DEVIATION REQUEST AND DECISION FORM

Project Name : Mayberry Phase 1
 Schedule No.(s) : PUDSP219, including SF1825 (Filing 1), VR2113 (Filing 1A), VR2322 (Filing 1B), SF2219 (Filing 3)
 Legal Description : NE1/4 of Sect 15 & N1/2 of Sect 14, Township 14 S, Range 63 W of 6th P.M., El Paso County, Colorado

A deviation from the standards of or in Section **2.4.1.E-1** of the Engineering Criteria Manual (ECM) is requested.

EXHIBIT 'C'
Example Deviation Compliant
Driveway Block Layout
(Actual As-Sold Configuration)

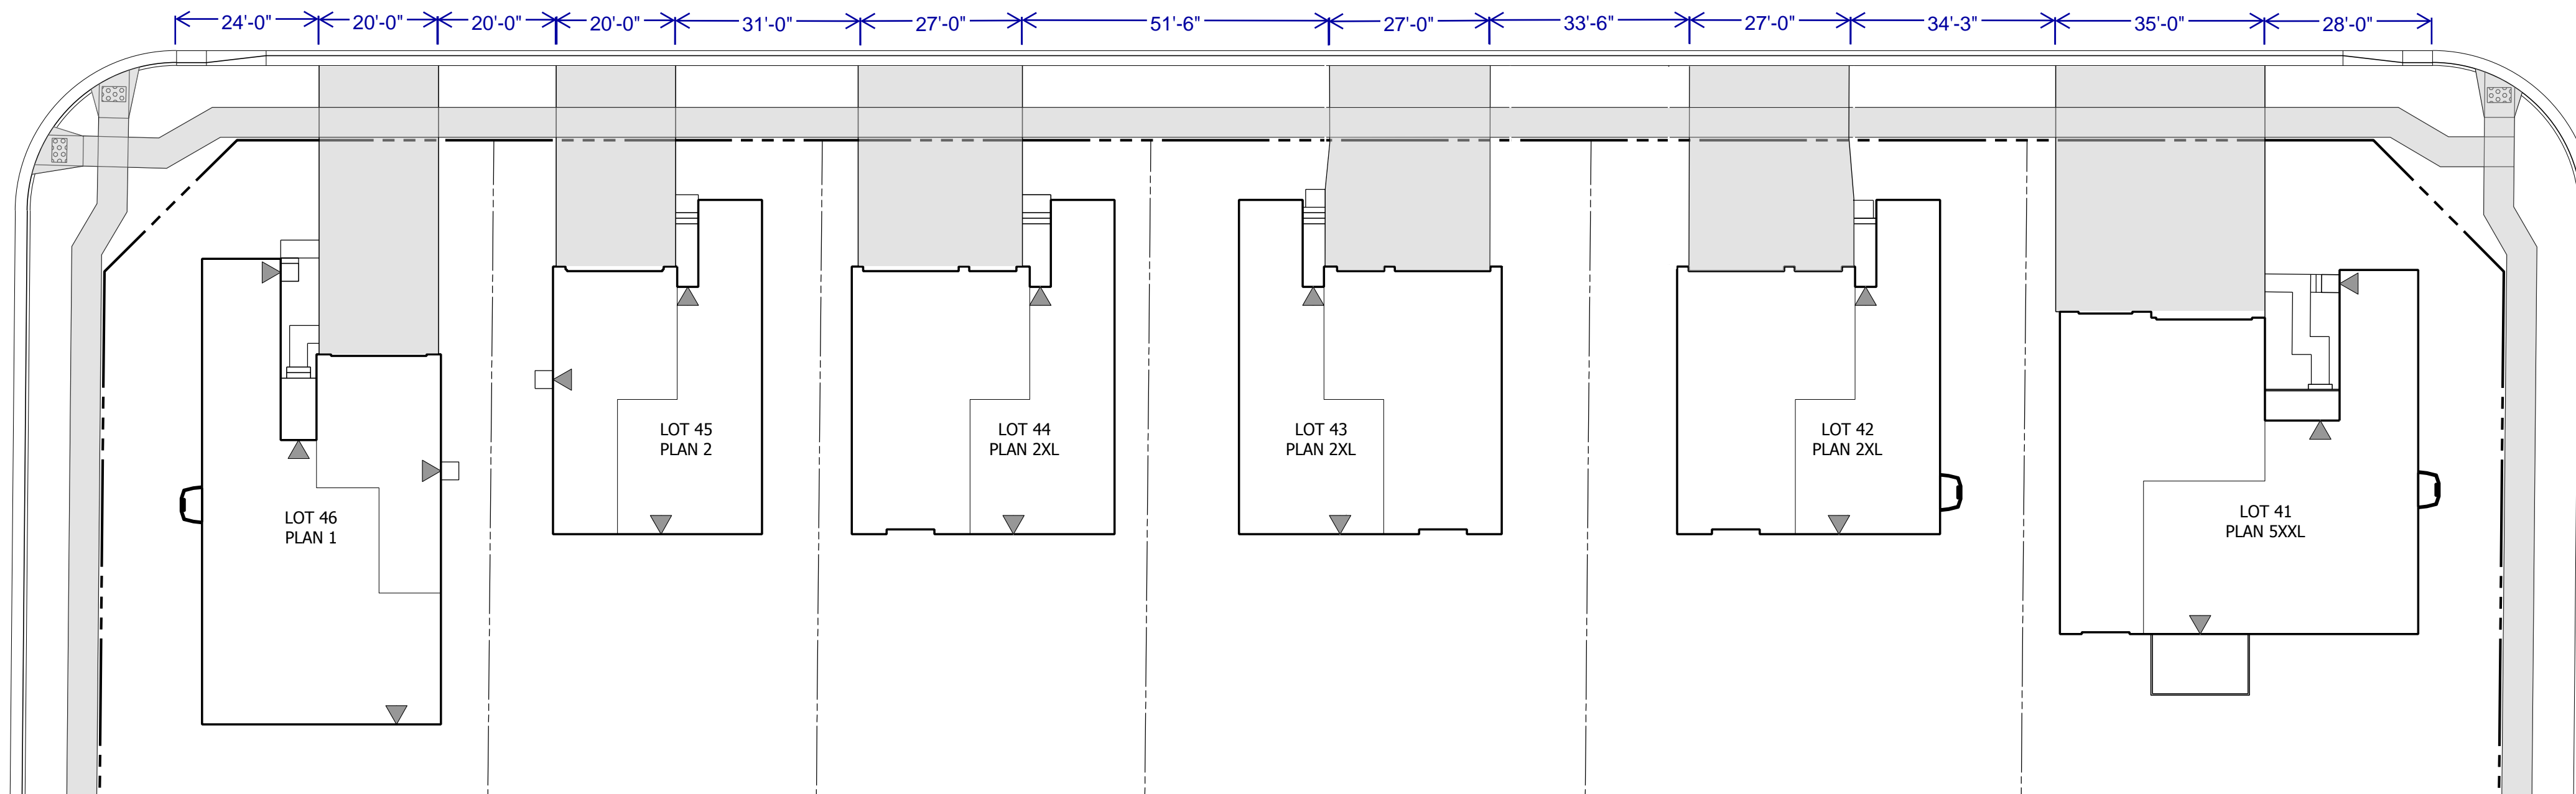
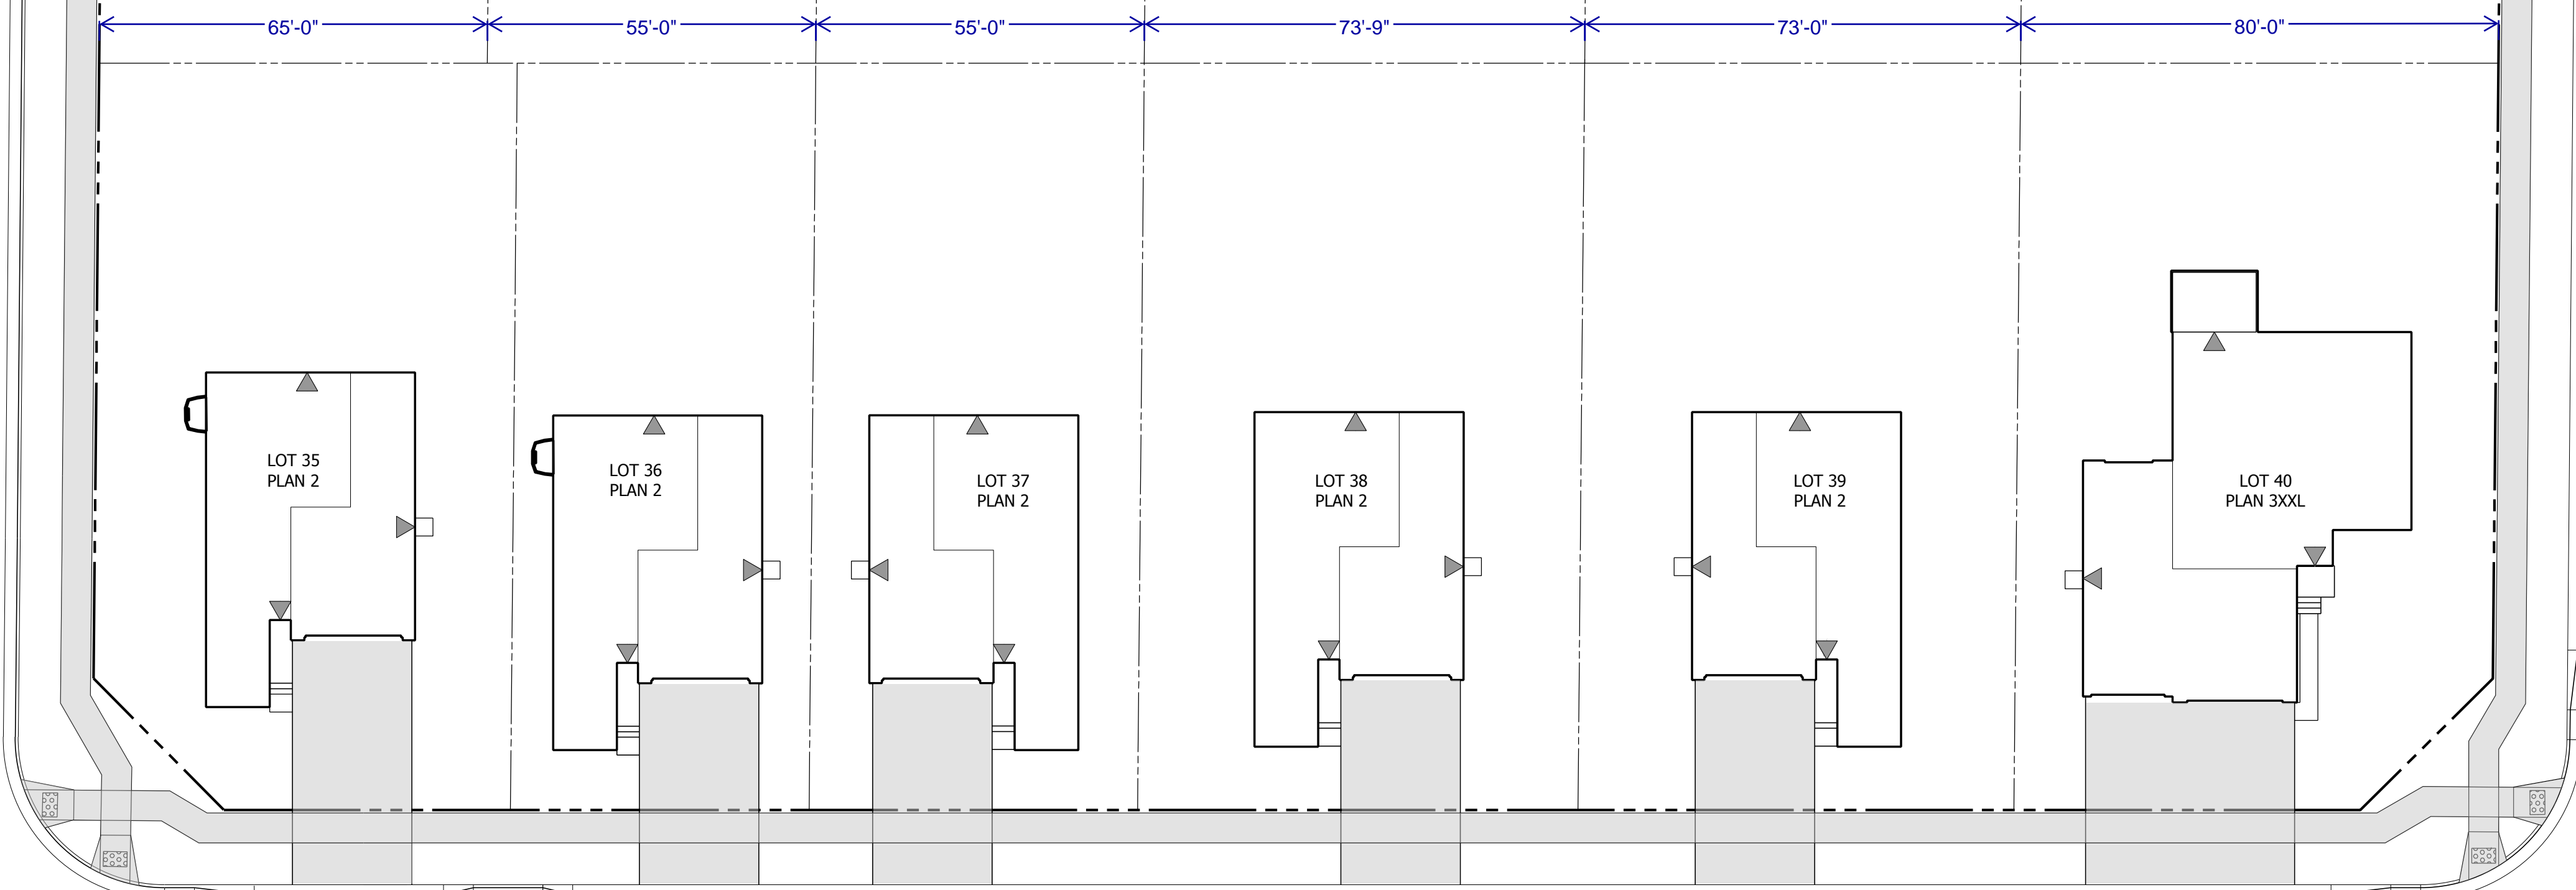
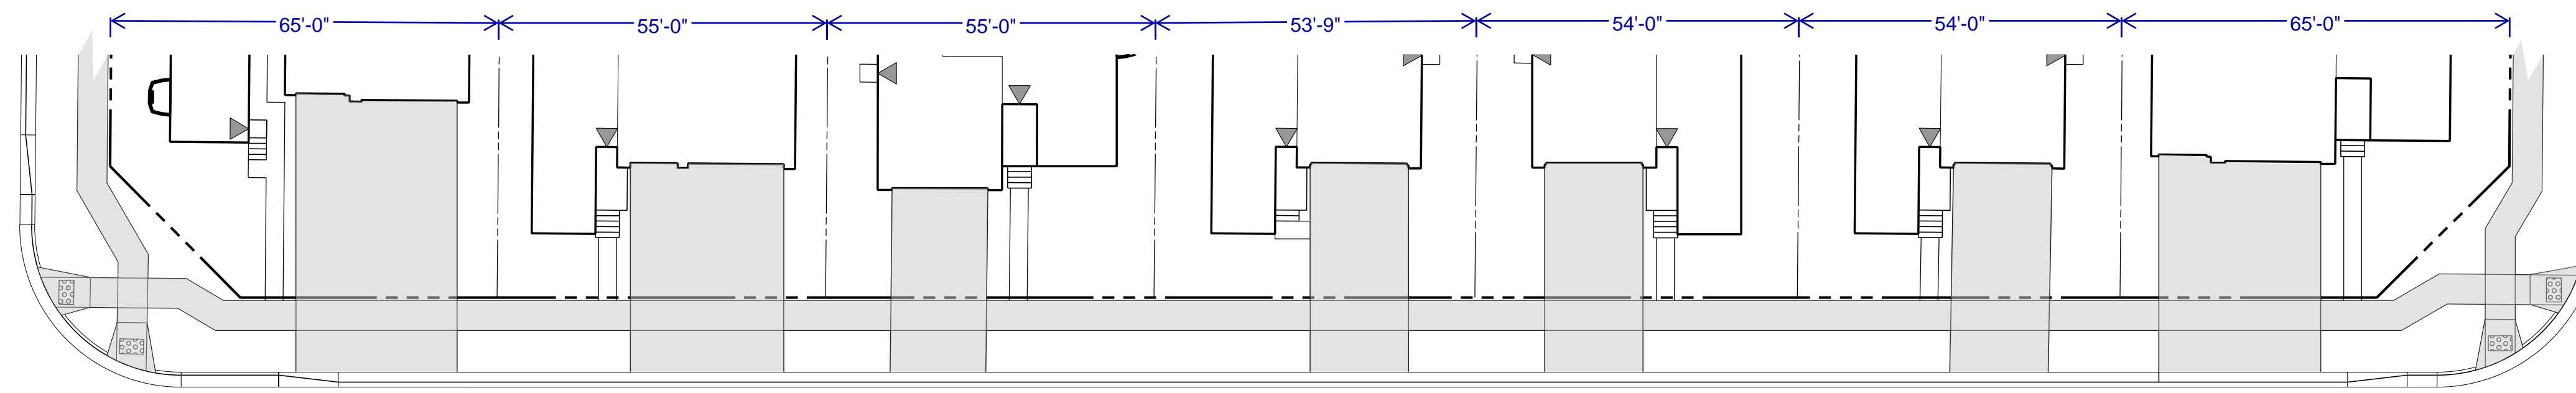
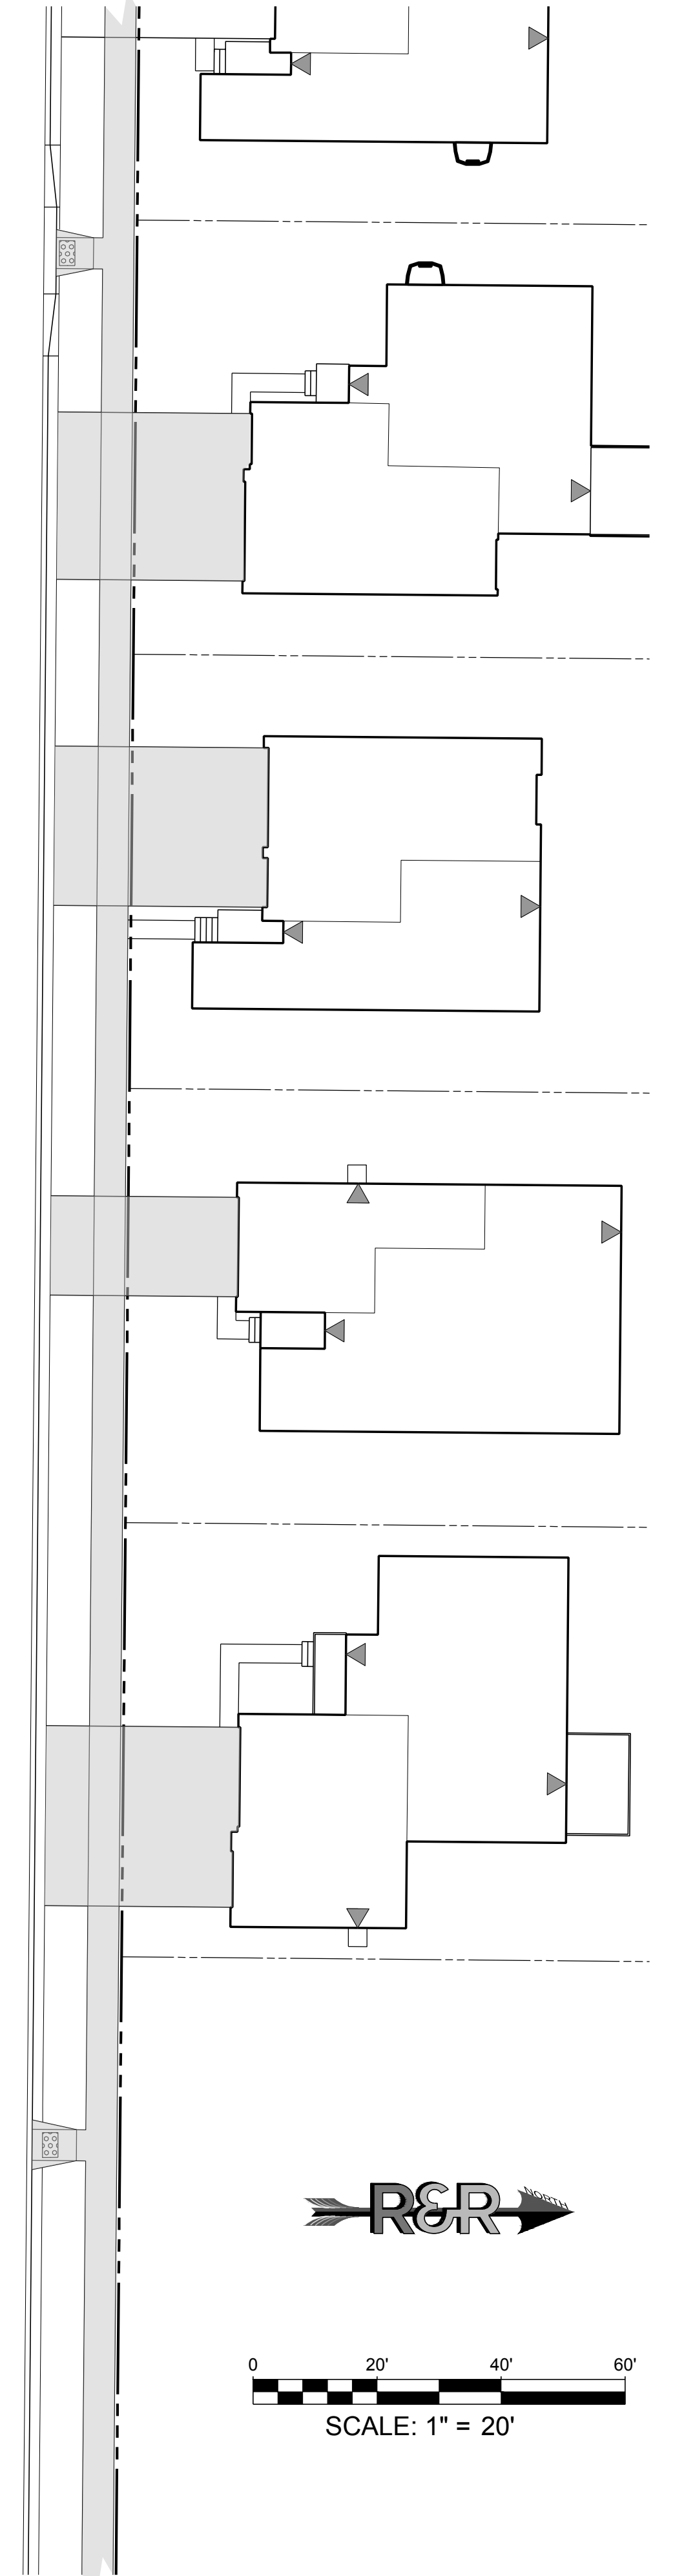
The Exhibit 'B' provides a schematic illustration of lots 45' in width with ECM maximum 24' wide driveways, all evenly spaced, while Exhibit 'C' illustrates a sample block layout of actual Mayberry homes designed with driveway layouts conforming to the criteria requested through this deviation request. These exhibits demonstrate that this deviation meets the design intent and purpose of the ECM standards.

- Maximum width of 24-feet for all lots narrower than 48-feet (per current ECM standard) at lot frontage, or
- Maximum width of 35-feet for all lots exceeding 48-feet, limited as otherwise noted, and
- Maximum width no wider than 50% of lot width as measured at face of garage door opening, and
- Maximum width up to 48" (24" each side) in excess of out-to-out opening of total garage door width, and
- Driveway access at intersections shall be located a minimum of 10' from the point of curvature or point of tangency of the curb line at the intersection (per current ECM standard)
